ITEM NO 2  
MEETING DATE Nov. 23, 2015  
STAFF Clay Frickey

**ADMINISTRATIVE HEARING OFFICER**

**STAFF REPORT**

**PROJECT:** Viale Collegio 2<sup>nd</sup> Floor Remodel, MJA150007

Figure 2: Viale Collegio Walking Distance From Nearest MAX Stop

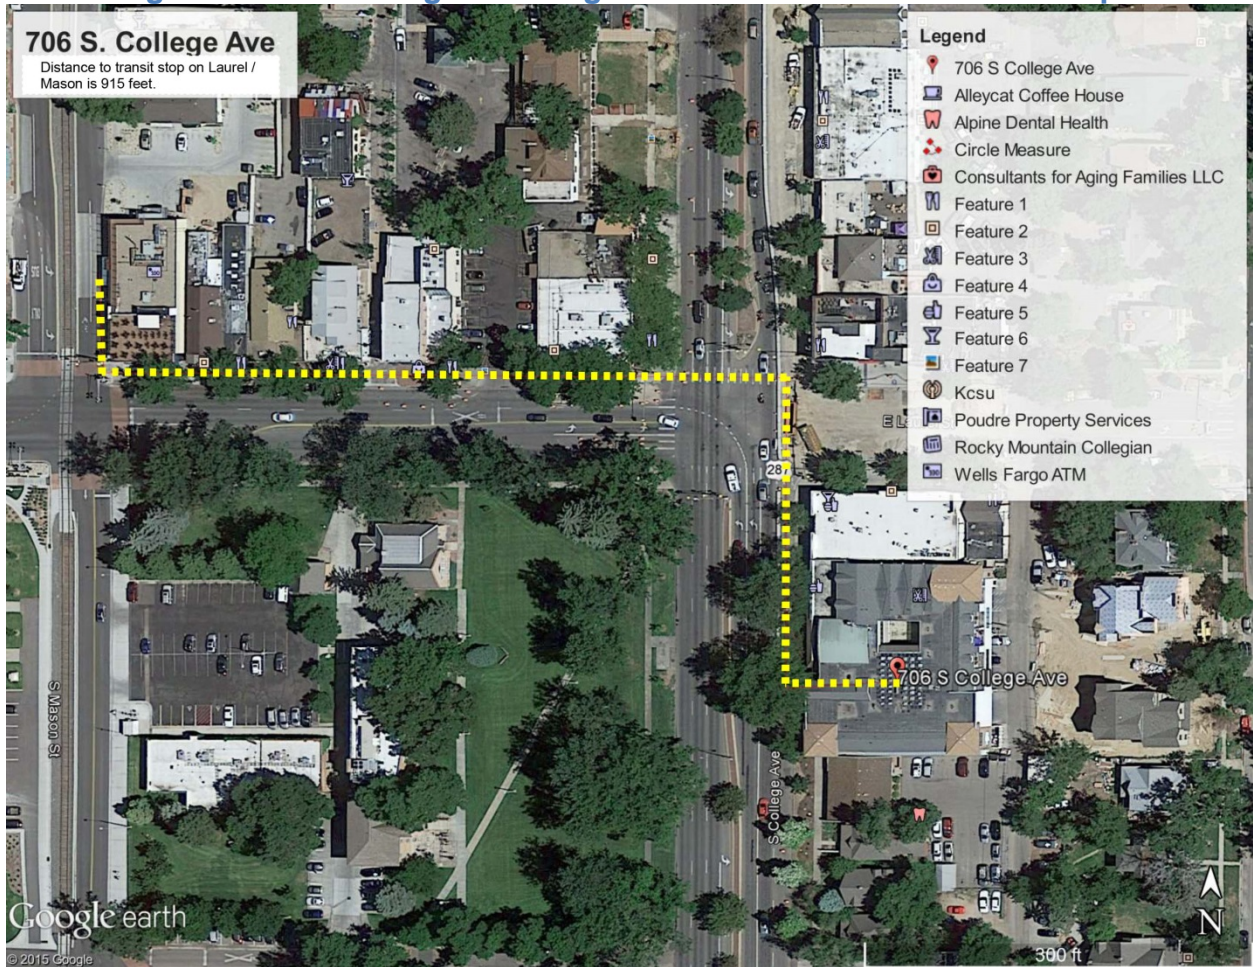
Land Use Code section 3.2.2(K)(1)(a)(1)(a) provides several demand mitigation strategies for multi-family dwellings located in the TOD Overlay Zone. The proposal uses two of the listed demand mitigation strategies to achieve a lower parking minimum: transit passes for each tenant and the site being within 1,000 feet of a MAX stop. Each demand mitigation strategy will result in a 10% decrease in the parking minimum or 20% cumulatively. The development agreement will contain language that will ensure a transit pass will be included for every renter for the duration of the project. The most remote entry of the building is 915 feet away from the MAX stop at Laurel St. and Mason St. following an ADA compliant, contiguous, and improved walkway. By meeting these alternative compliance measures, the minimum parking required for the residential component of the project goes from 26 spaces down to 21 spaces (rounded up from 20.8).
